**KNOXVILLE/KNOX COUNTY METROPOLITAN PLANNING COMMISSION  
 USE ON REVIEW REPORT**

▶ **FILE #:** 2-B-18-UR **AGENDA ITEM #:** 60  
 POSTPONEMENT(S): 2/8/2018 - 3/8/2018 **AGENDA DATE:** 4/12/2018  
 ▶ **APPLICANT:** **STUART ANDERSON**  
 OWNER(S): Northshore Market Investors

▶ **ZONING:** **PC-1(k) (Retail and Office Park)**  
 ▶ **EXISTING LAND USE:** **Vacant land**  
 ▶ **PROPOSED USE:** **Medical office**  
 HISTORY OF ZONING: Rezoned from TC-1 to PC-1 with conditions related to meeting intent of TC-1 standards (10-G-10-RZ).  
 SURROUNDING LAND USE AND ZONING: North: Vacant land, Target / PC-1(k) (Retail and Office Park)  
 South: Boardwalk Blvd, vacant land / TC-1 (Town Center)  
 East: Town Center Blvd., vacant land / PC-1(k) (Retail and Office Park)  
 West: Vacant land / TC-1 (Town Center) & PC-1(k) (Retail and Office Park)  
 NEIGHBORHOOD CONTEXT: This property is situated with the Northshore Town Center development, which is developed with a mix of office, commercial, a school and various types of residential uses. Northshore Elementary School is located one block to the west.

3 MONUMENT SIGN FRONT ELEVATION  
 A4.2 SCALE: 1/2" = 1'-0"

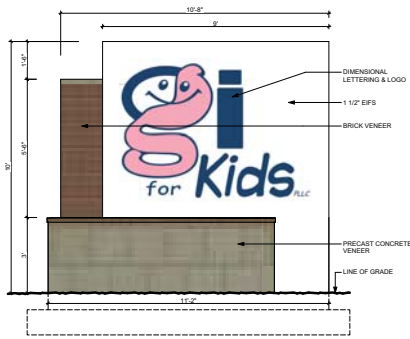
- 11) Revising one of the two proposed monument signs to meet requirements for an incidental sign in Article 8, Section 8.4 of the sign ordinance.
- 12) Revising the bicycle parking location to meet the requirements of the City of Knoxville Zoning Ordinance and the City of Knoxville Department of Engineering.

approved in 2011. This sign plan allowed one monument sign per property and provided standards for detached and attached signs. This proposal has two monument signs. Staff is recommending that one of those two monument signs be revised to meet the incidental sign requirements of the City of Knoxville Zoning Ordinance, which allows a monument sign to be 16 square feet and 6 feet tall. However, only 20 percent of this sign can be dedicated to a name or logo of the business.

**L2.0**

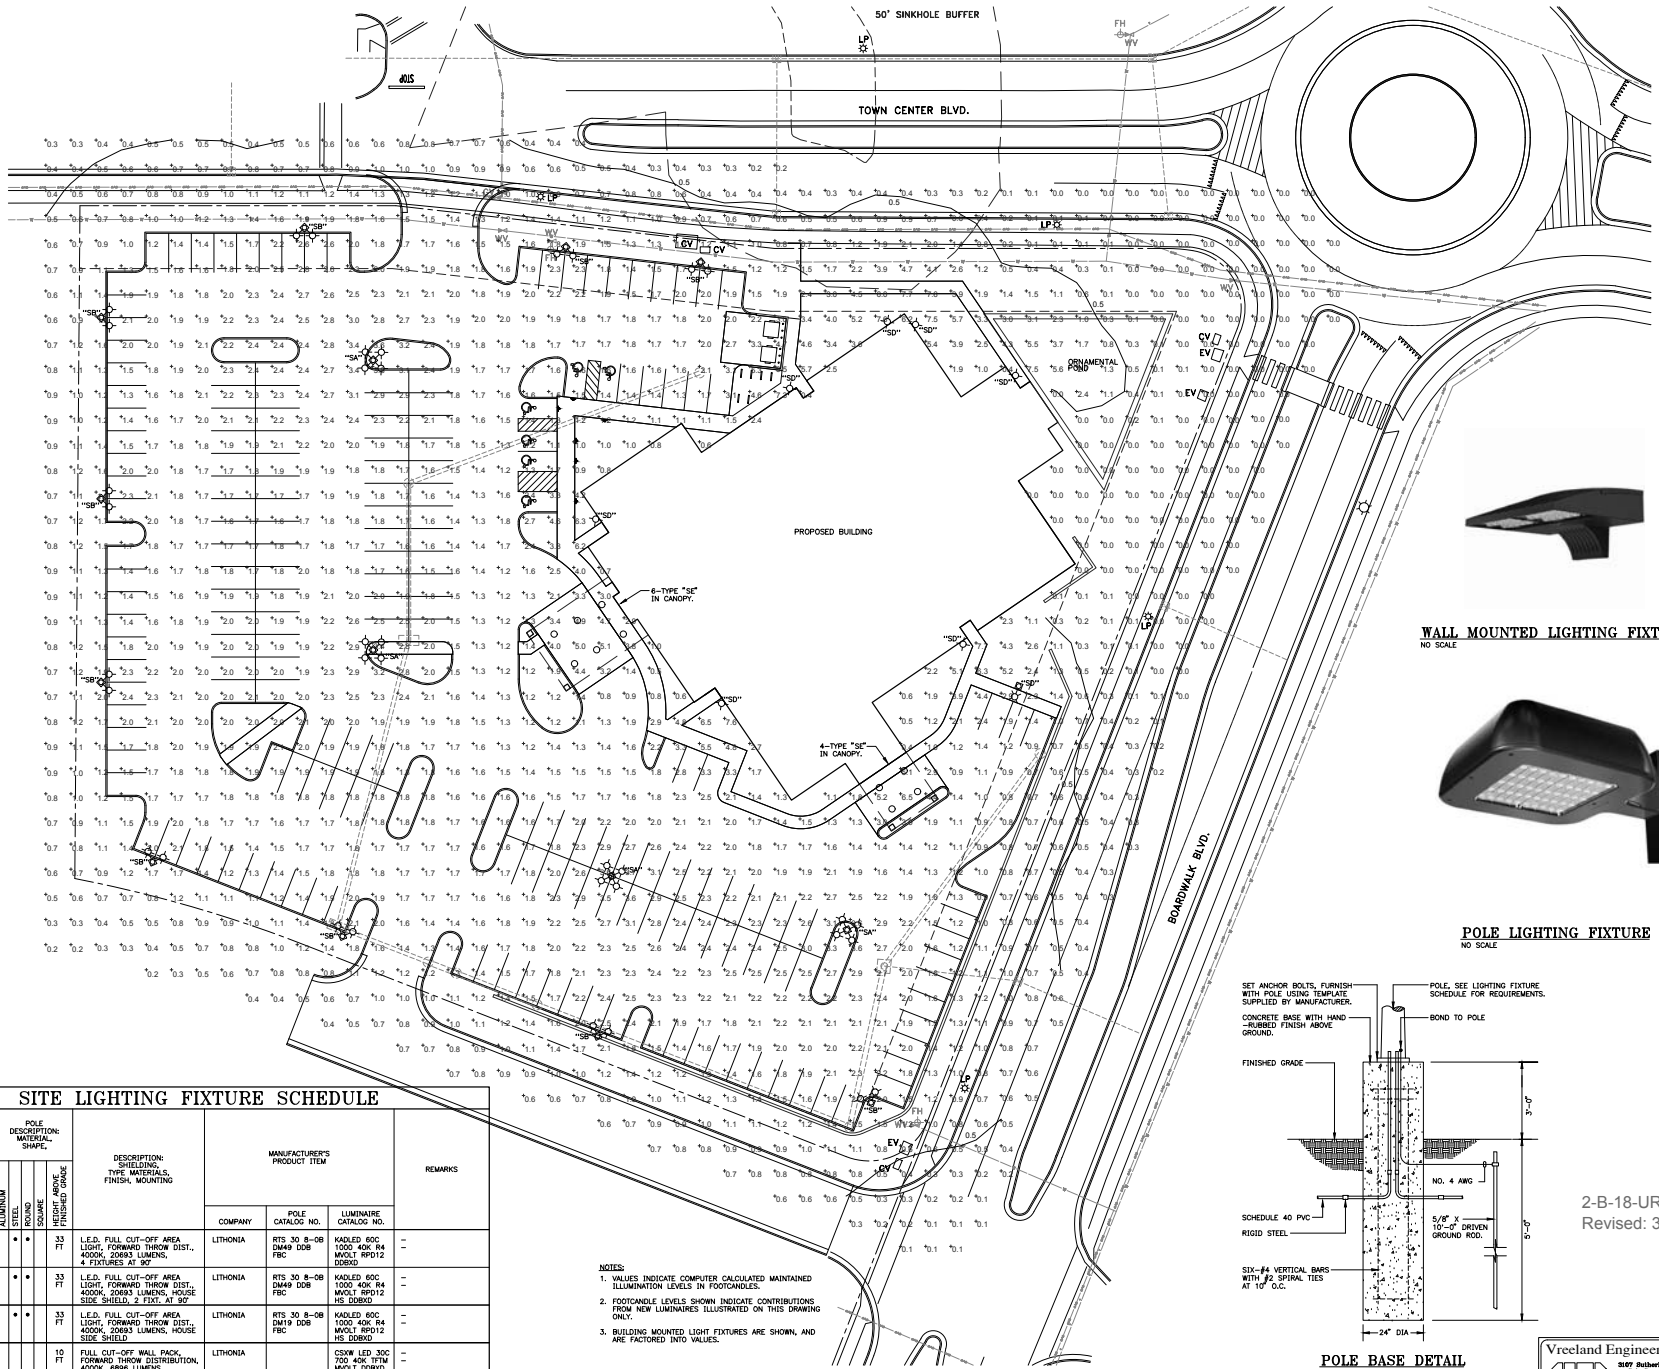
- 10) Installing all landscaping as shown on the landscape plan (sheet L1.0), and adjacent streetscape landscaping, within six months of issuance of occupancy permit for the development.
